Access Compliance Report

Public Rights-of-Way

Intersection ID: 10014519	Main Street: UNIVERSITY_POINTE_BV	Cross Street: N/A	Location: NE
ADA ID: 302D23A0723D	Ramp Type: Perp	Initial Pass/Fail: Fail	Overall Compliance: No
Severity Score: 8.75			
Codes/Mitigation Info/Possible Solution		Field Measurements/Component Compliance

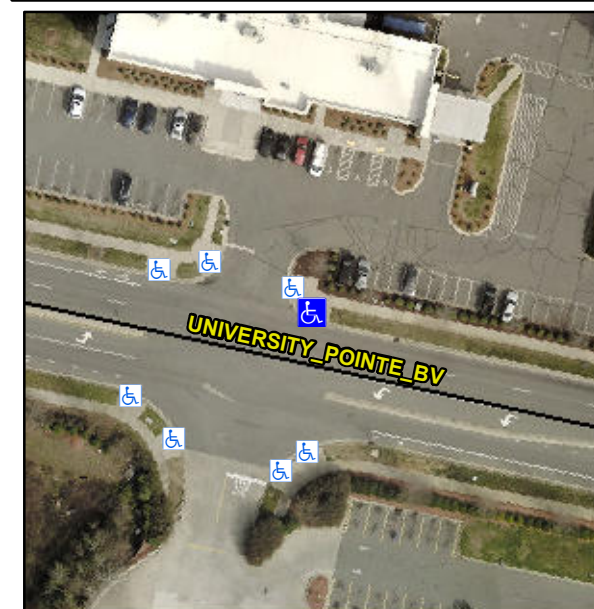
R304.5.1

Compliance	Description	Data	Compliance	Description	Data
N/A	Ramp Length (in)	96.0	Yes	Ramp Slope (%)	6.3
No	Ramp Width (in)	47.0	Yes	Ramp XSlope (%)	1.0
N/A	Flare Type LT	N/A	N/A	Flare Type RT	N/A
N/A	Flare Slope LT (%)	N/A	N/A	Flare Slope RT (%)	N/A
N/A	Flare Traversable LT?	N/A	N/A	Flare Traversable RT?	N/A
N/A	Landing Length (in)	N/A	N/A	DWS Provided?	N/A
N/A	Landing Width (in)	N/A	N/A	DWS Contrast?	N/A
N/A	Landing Slope (%)	N/A	N/A	DWS Length (in)	N/A
N/A	Landing X Slope (%)	N/A	N/A	DWS Full Width?	N/A
N/A	Landing Curb? (Y/N)	N/A	N/A	DWS Offset (in)	N/A
N/A	Shared Landing?	N/A			
N/A	Gutter Ponding?	N/A	N/A	Gutter Slope (%)	N/A
N/A	Gutter Lip Ht (in)	N/A	N/A	Gutter X Slope (%)	N/A
N/A	Painted X Walk1?	No	N/A	Painted X Walk2?	N/A
	X Walk 1 Direction	To S		X Walk 2 Direction	N/A
N/A	X Walk 1 Width (in)	N/A	N/A	X Walk 2 Width (in)	N/A
	X Walk 1 Slope (%)	1.8		X Walk 2 Slope (%)	N/A
	X Walk 1 X Slope (%)	2.1		X Walk 2 X Slope (%)	N/A

Remove & Replace Entire Ramp.
